N330NAS1

# TECHNICAL BULLETIN

Service Action: Emergency Call (eCall) And Breakdown Call (bCall) Functions Missing

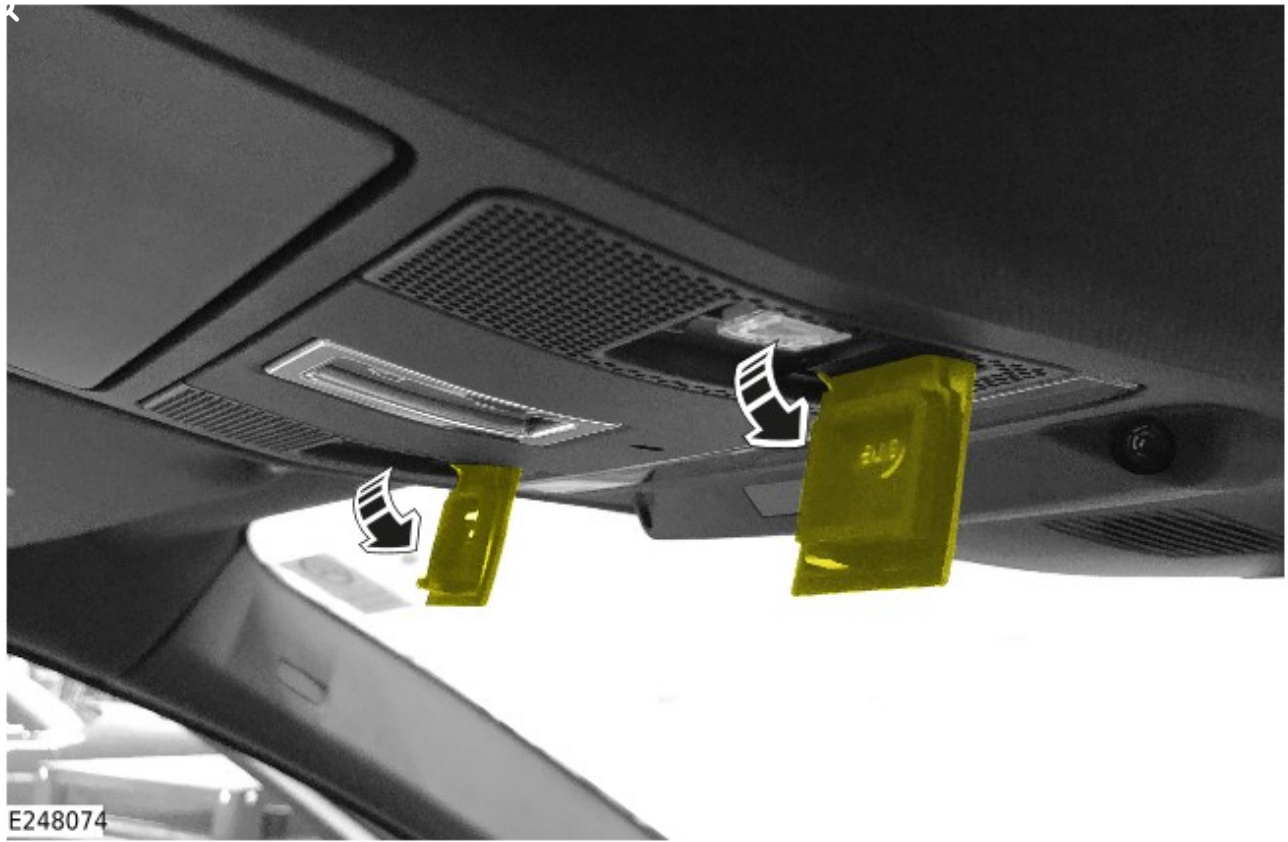
Open the Emergency Call (eCall) and the Breakdown call (bCall) buttons.

Visually inspect the front overhead console.

- If the front overhead console does have the eCall and the bCall buttons installed, go to Step 4.
- If the front overhead console does not have the eCall and the bCall buttons installed, go to Step 3.

3 Renew the front overhead console (see TOPIx Workshop Manual section 501-12: Instrument Panel and Console - Front Overhead Console).
